Hurricane Planning Commission Meeting Agenda

November 14, 2024
5:30 PM
Hurricane City Offices 147 N 870 W, Hurricane

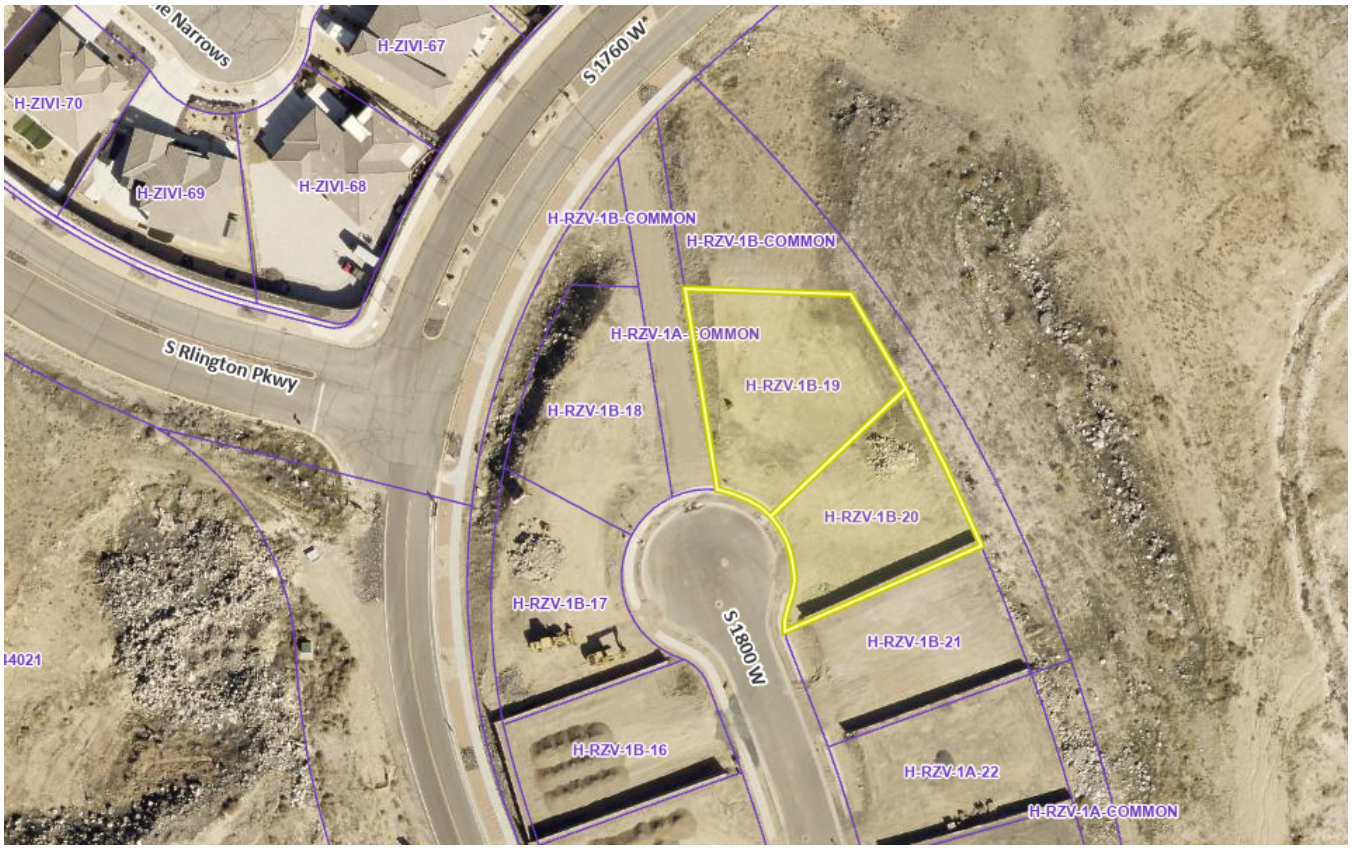
1. **Public Works:** Need to make sure that the utilities for each lot stay with the appropriate lot and not end up on the other side of the lot line.
2. **Power:** No concerns.
3. **Water:** Okay. Make sure meters are located on lot to be serviced.
4. **Streets:** Okay with amendment.
5. **Sewer:** Each lot has an existing lateral. If the lot line adjustment causes a lateral to cross the lot line a new lateral will need to be installed.
6. **Engineering:** Engineering supports approving the intent of the amendment. Corrections must be made before the plat is printed, signed, and recorded. Please provide an updated plat to jeremy@hurricane.utah.gov after the amended final plat is approved by the Planning Commission. Additional comments provided to the applicant.
7. **Fire:** Approved.
8. **Fiber:** No comment.
9. **Gas:** Okay with gas.

1. The plat meets all standards for amending final plats contained in Utah Code 10-9a-608, subdivision amendments, updated in 2023. The following are key requirements of the code:
    a. Depicts only the portion of the subdivision that is proposed to be amended.
    b. Includes a plat name distinguishing the amended plat from the original plat.
    c. Provides an amendment note referencing the original plat and describing the changes. The second sentence of this note can be removed.
2. The Final Plat needs a full review by the City Engineering Department for surveying details.

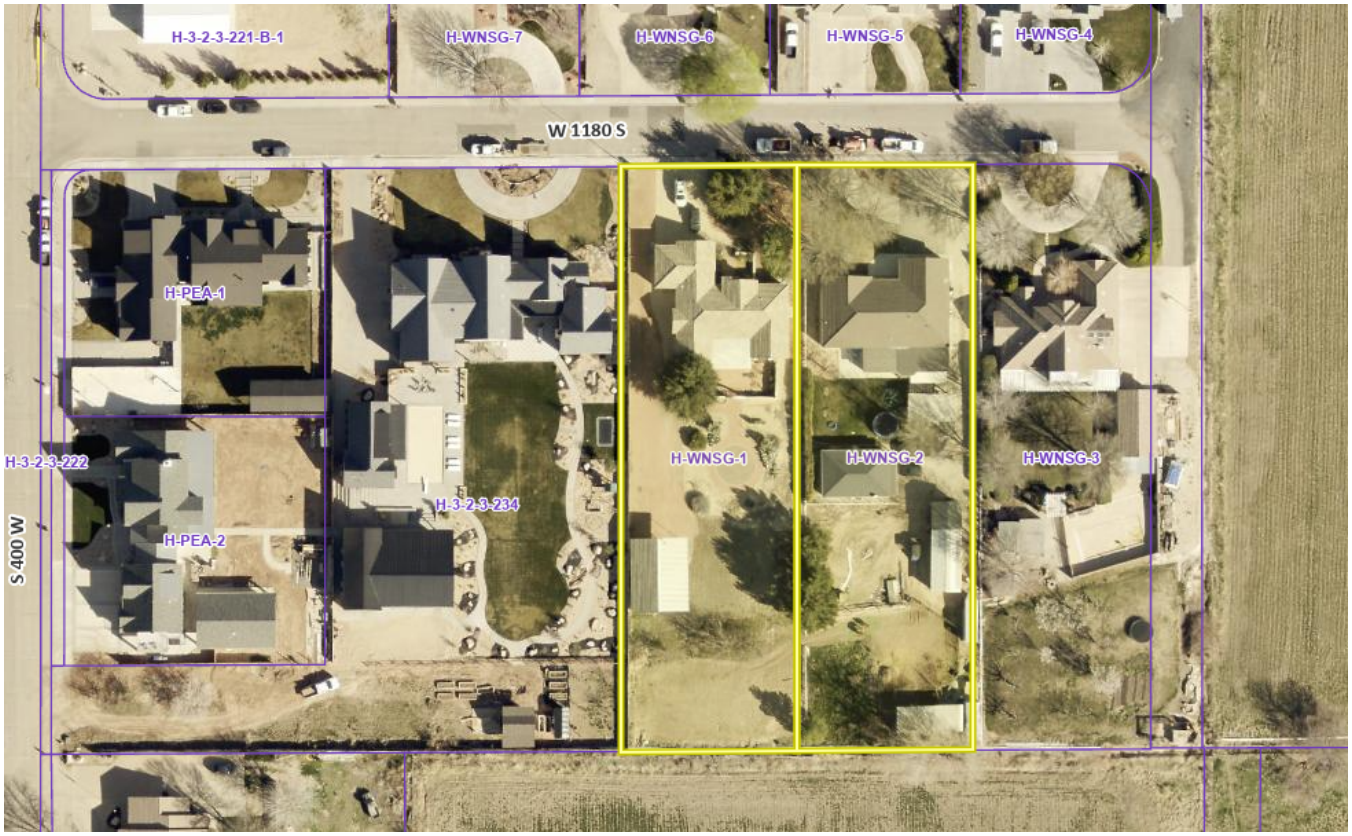
1. **Public Works:** Public Works has no comments.
2. **Power:** No concerns.
3. **Water:** Okay.
4. **Streets:** Okay with amendment.
5. **Sewer:** No comments.
6. **Engineering:** Engineering supports a lot line adjustment.Encourage the Planning Commission to approve the Amended Final Plat and tell the applicant to get me an updated final plat to review before it's printed, signed, and recorded.
7. **Fire:** 1. Any new home will need to be within 250' of a fire hydrant. 2021 IFC appendix C. 2. Any road that is over 150' will require a fire department approved turnaround. 2021 IFC appendix D.
8. **Fiber:** No comment.
9. **Gas:** Okay with gas.

1. The plat meets all standards for amending final plats contained in Utah Code 10-9a-608, subdivision amendments, updated in 2023. The following are key requirements of the code:
    a. Depicts only the portion of the subdivision that is proposed to be amended.
    b. Includes a plat name distinguishing the amended plat from the original plat.
    c. An amendment note referencing the original plat and describing the changes needs to be provided.
2. The Final Plat needs a full review by the City Engineering Department for surveying details.

Location is approximate

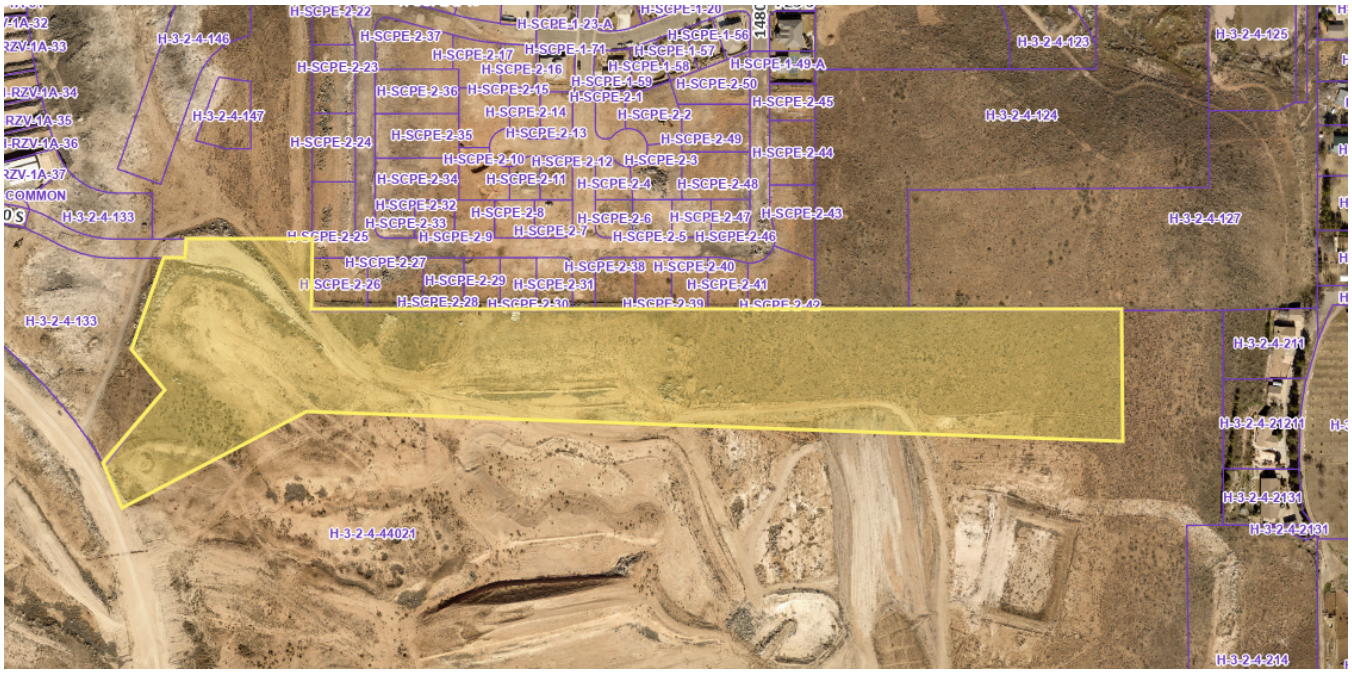
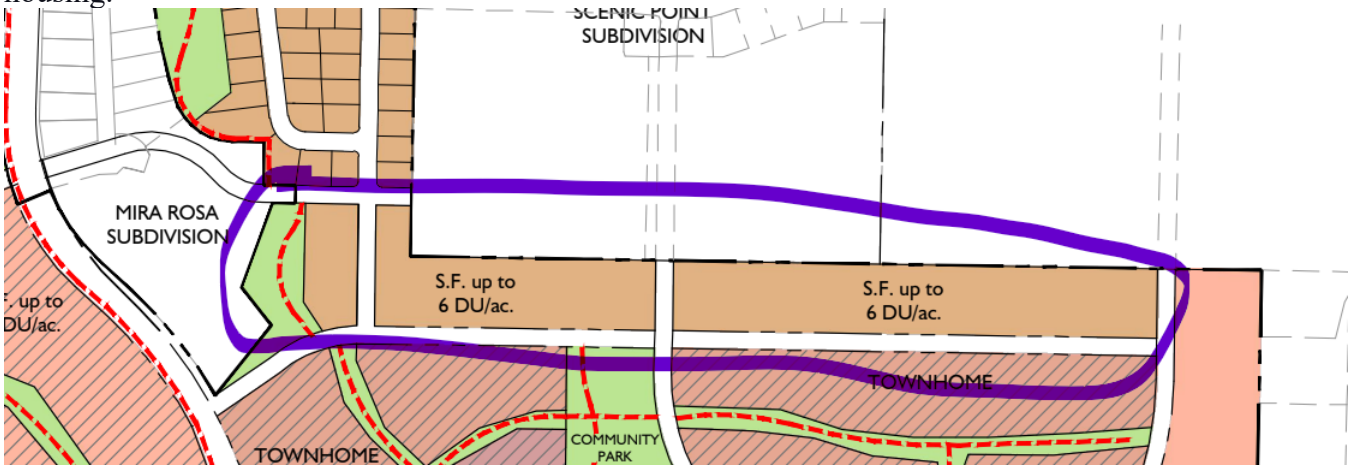
1. **Density:** This area was designated as "Single Family up to 6 dwelling units per acre," as seen below. They are proposing 45 single family lots over 13.5 acres which is about 3.33 units per acre. The lots vary in size from 5,000 sq ft to 9,211 sq ft, and are smaller lot single family homes which meets many of the goals of the City as well as the State in terms of providing more housing.

2. Setbacks are shown on the site plan. The side setbacks can be adjusted to match the PDO setbacks of "minimum 5', 15' aggregate"

3. **Open Space**: The master plan shown above shows a trail connecting from 920 S to 840 S behind the houses (see above). This will need to be shown on the plans. Keeping that hillside as open space is shown on the master plan and the preliminary site plan. Hurricane City will require that the open space have a final site plan that needs to be approved by the Planning Commission.

Slope map of the area

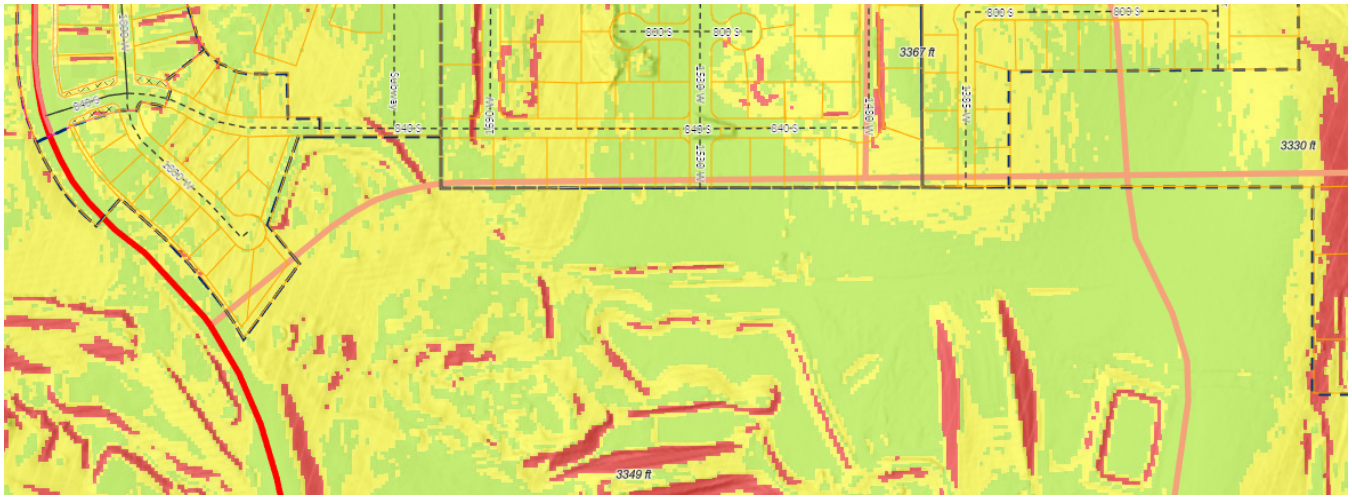
Engineering will have to sign off on all grading and retaining wall heights. Staff would recommend that the principles of the sensitive lands ordinance be generally followed.

Map is approximate.

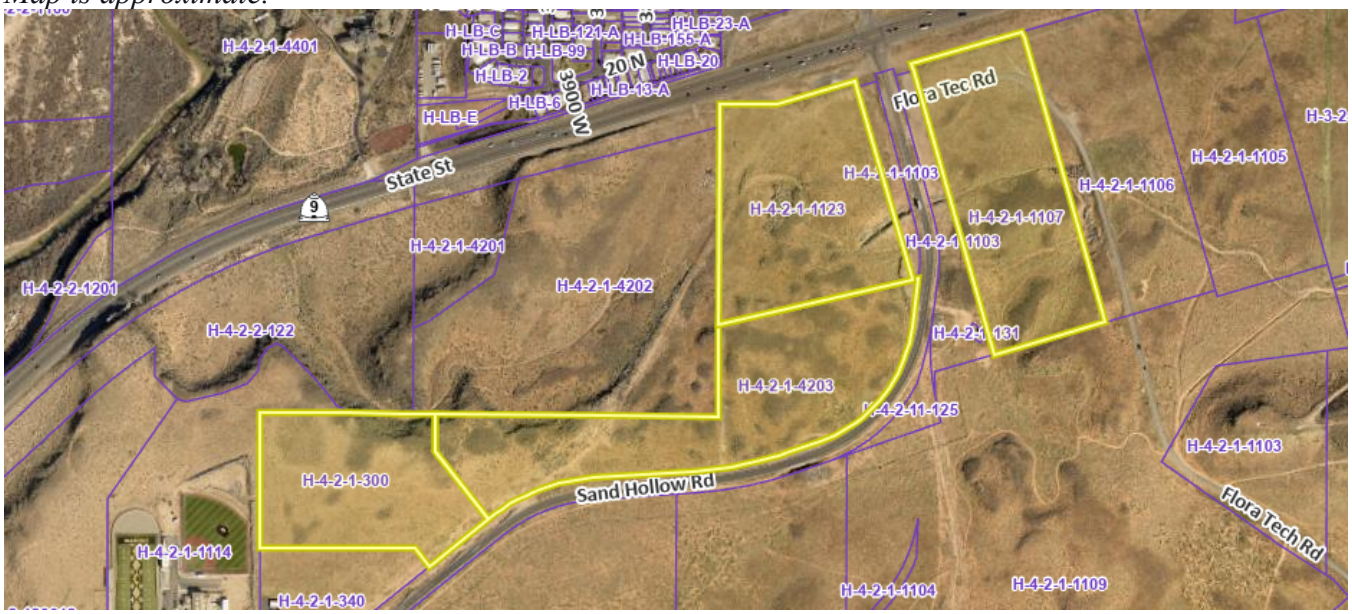
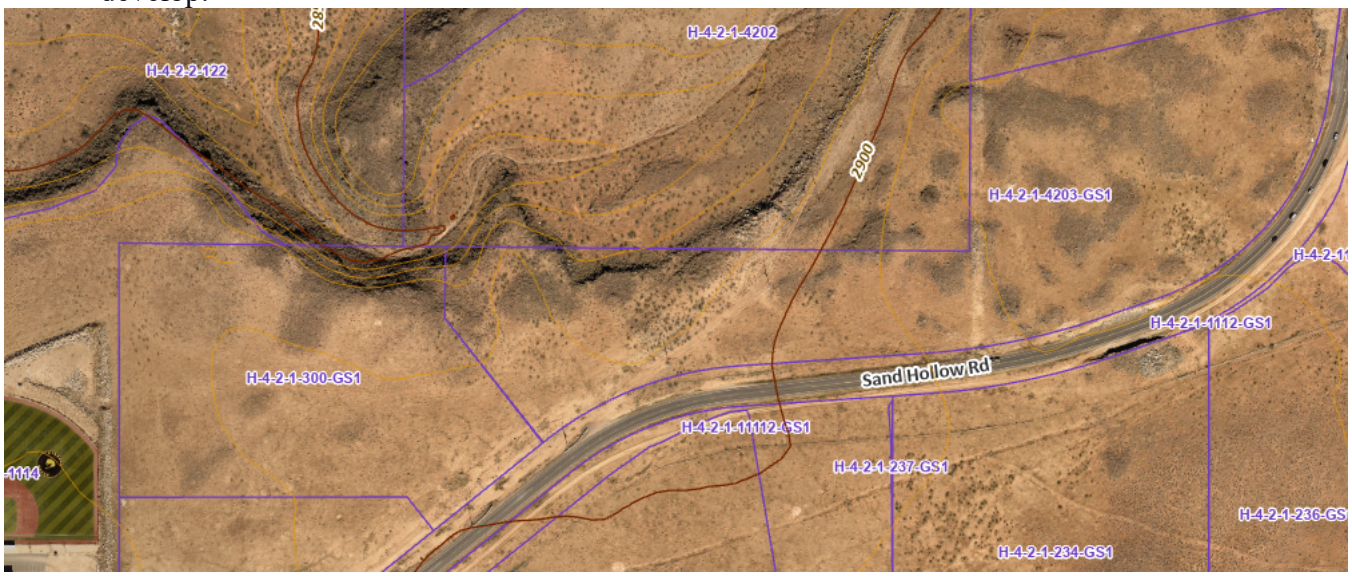
The following items will need to be addressed:

4. Preliminary site plans will need to be turned in for each lot.
5. Access points between Lots 1 and 2 will need to be properly spaced.
6. There are some cliffs within this property. These are near the property boundaries and should be easy to avoid, but the Sensitive Lands ordinance will need to be addressed when these lots develop.

7. A note indicating that the property is not in a desert tortoise take area has been provided.
8. Utilities are not available to the property but will be with the PID buildout.
